SECOND/THIRD READING SUMMARY SHEET

ZONING CASE NUMBER: C814-20070009.01 The Terrace in Oak Hill

CASE: C814-2007-0009.01 **P.C. DATE:** May 13, 2014
The Terrace in Oak Hill Planned Unit Development
(formerly West 71 Office Park Planned Unit Development)

SUBJECT: Terrace in Oak Hill (Formerly called West 71 Office Park)
Planned Unit Development Ordinance Number 20070726-104

EXHIBIT D-2

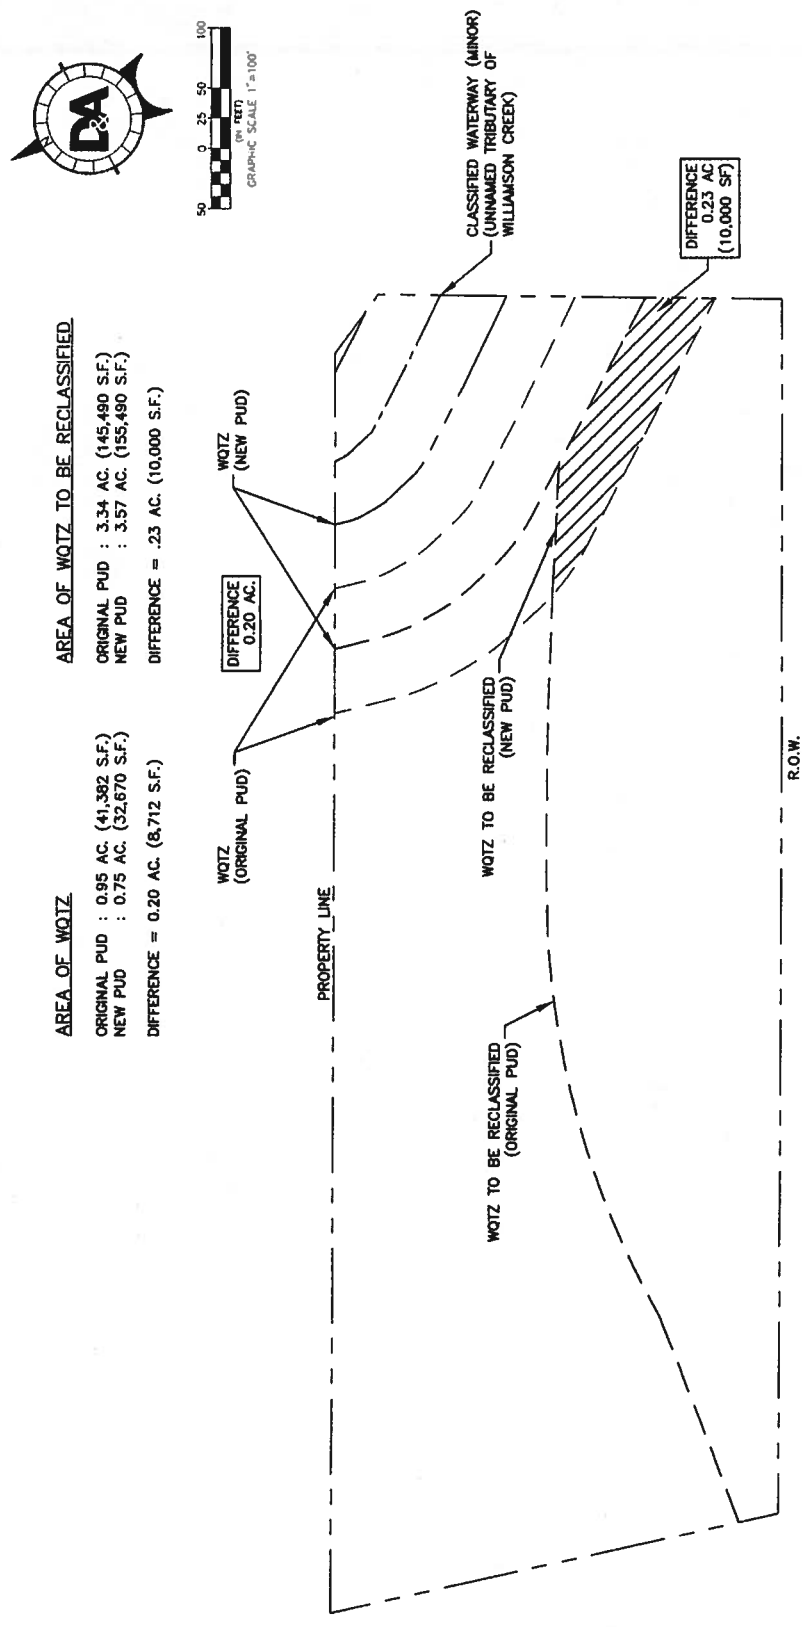
The current proposal carries forward the grant to reclassify the Williamson Creek WQTZ to Uplands Zone (see Exhibit D-2). The underlying logic remains the same – that the site does not drain to Williamson Creek. There is still WQTZ and CWQZ acreage on site, but it pertains to the unnamed tributary along the northeastern corner. As proposed, the amended PUD would contain 0.75 acres of WQTZ and 0.38 acres of CWQZ, totaling 1.13

Therefore, the applicant proposes to revise the Critical Water Quality Zone and Water Quality Transition Zone of the unnamed waterway located at the northeast corner of the property (Exhibit D-2 WQTZ Reclassified and Exhibit D-3 CWQZ Reclassified) to reflect current GIS data. This revision will not alter the language of the approved PUD Ordinance; but will require a revision of Land Use Plan associated with the PUD Ordinance (Exhibit C-1 Proposed Land Use Plan and Exhibit C-2 Proposed Land Use Notes).

EXHIBIT D-3

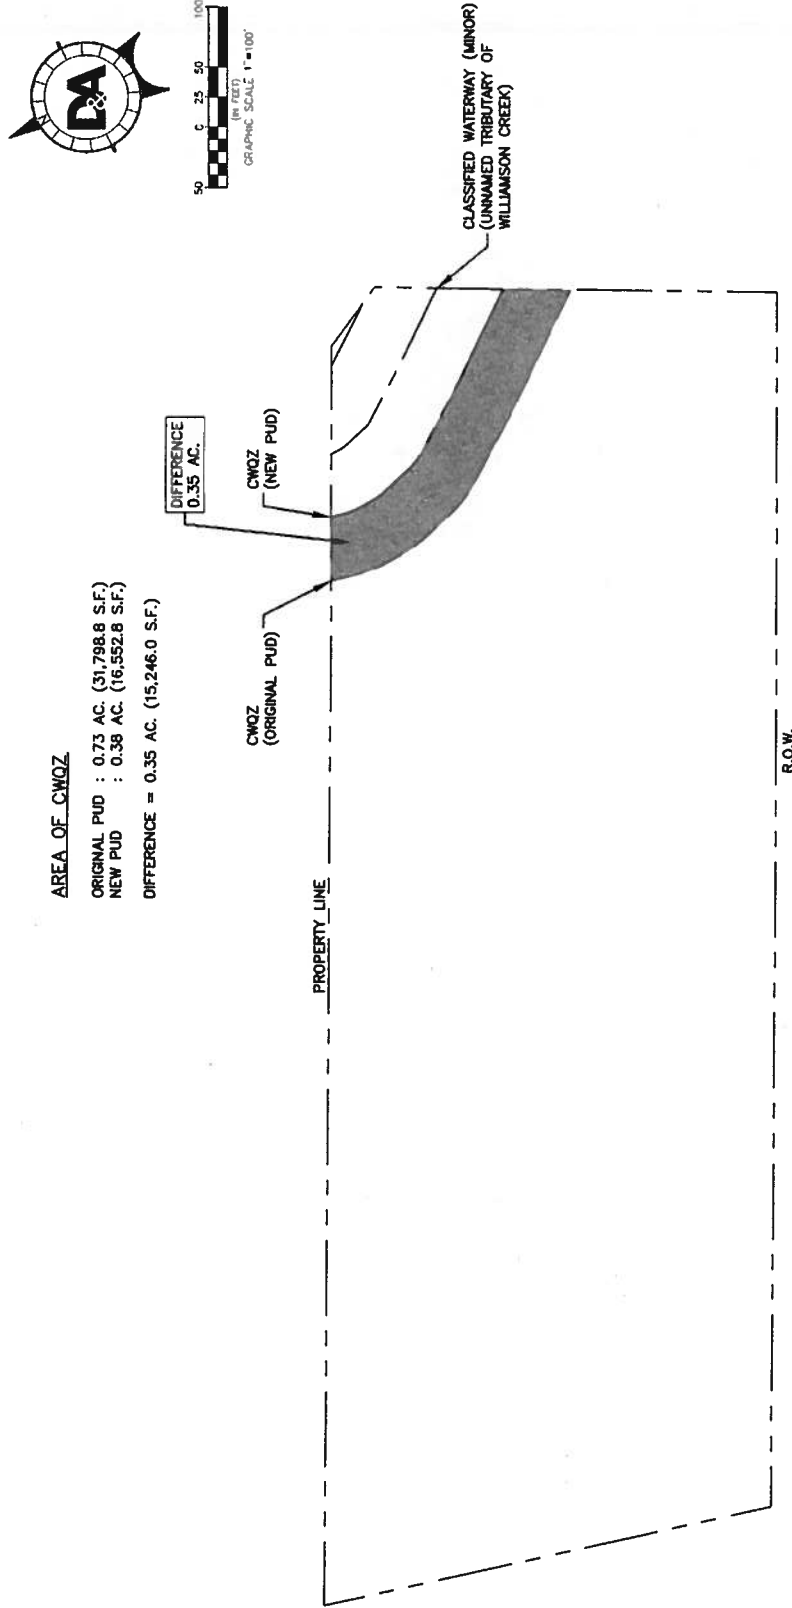
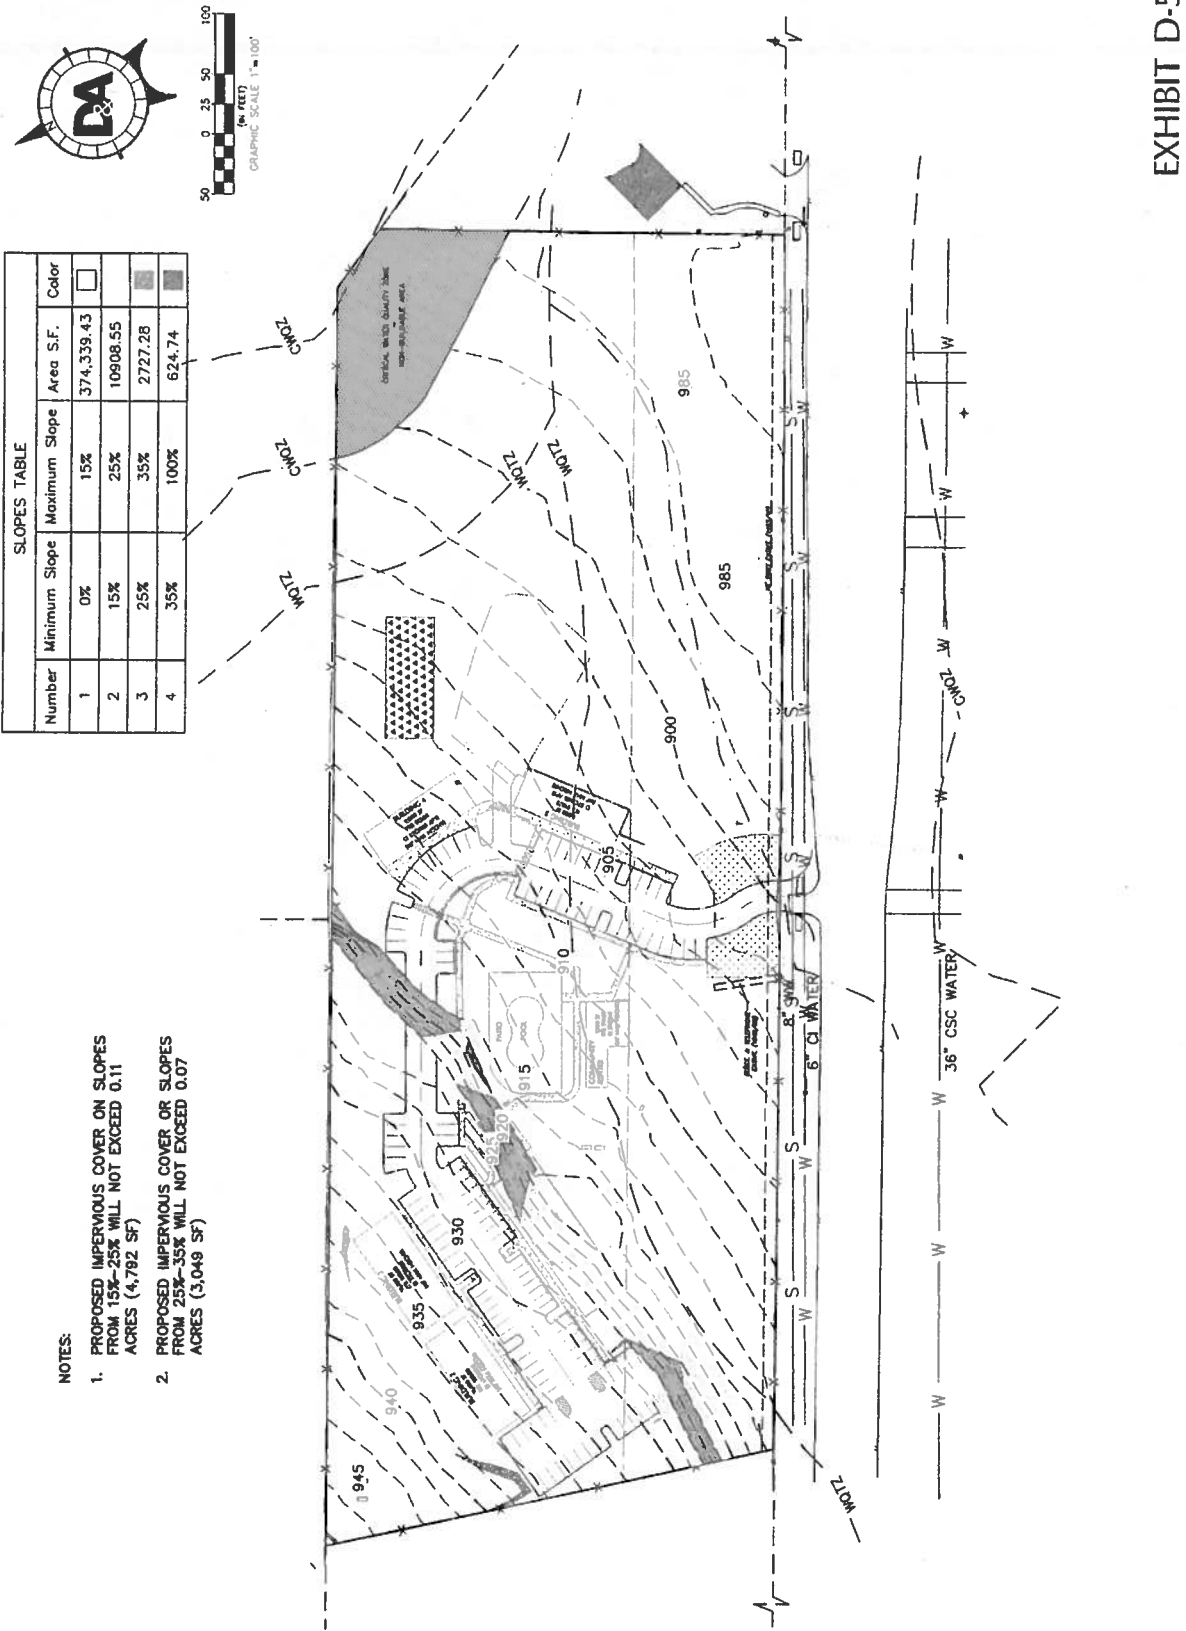
DIFFERENCE
0.35 AC.

EXHIBIT D-6

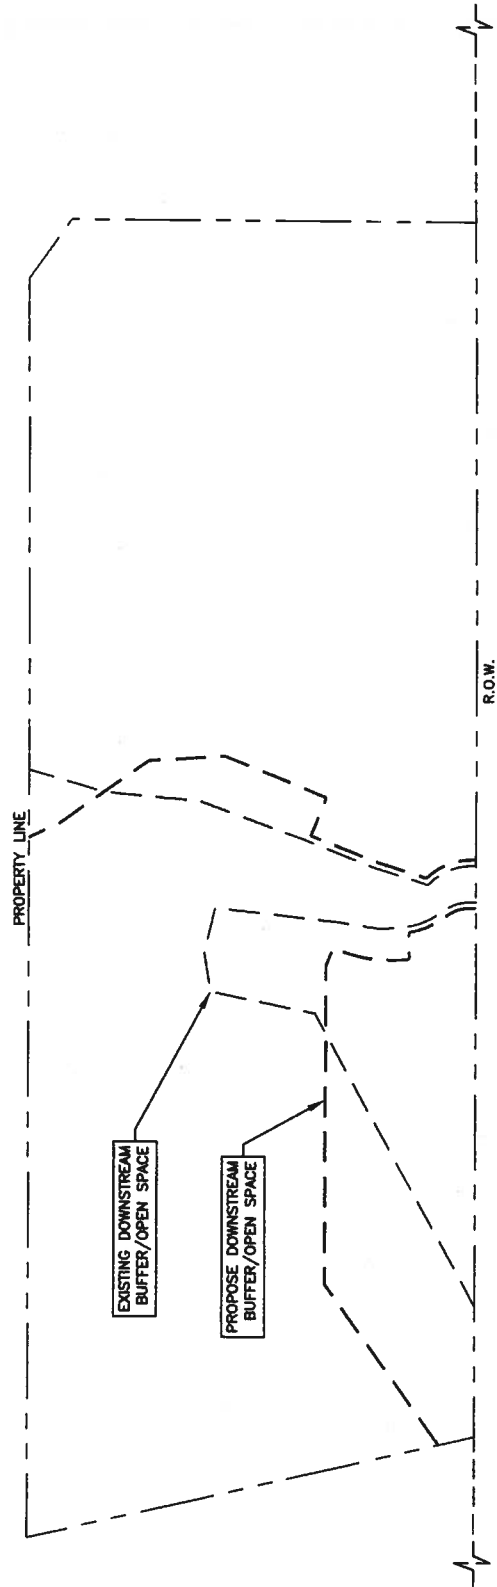
The downstream buffer area is carried forward in the proposed amendment, and in fact, is enlarged by at least 0.4 acres. As currently envisioned, the buffer area would be 3.75 acres (see Exhibit D-6). Acknowledging that this buffer area might be modified as the final site plan is developed, the minimum area of the buffer would be 3.745 acres, but it could potentially be enlarged further. That minimum acreage still represents a 12.28% increase over the existing PUD's downstream buffer area. The utility connections, drainage facilities, and permeable walking trails proposed in the buffer area are either already allowed in the PUD or allowed by current code. There is no expansion of the permitted infrastructure uses, but there is a clarification of PUD verbiage in light of uses specified in the existing PUD; nonetheless, this area is to remain largely in its natural and undisturbed state.

EXISTING DOWNSTREAM BUFFER/OPEN SPACE = 3.37 AC.
 PROPOSED DOWNSTREAM BUFFER/OPEN SPACE = 3.75 AC.
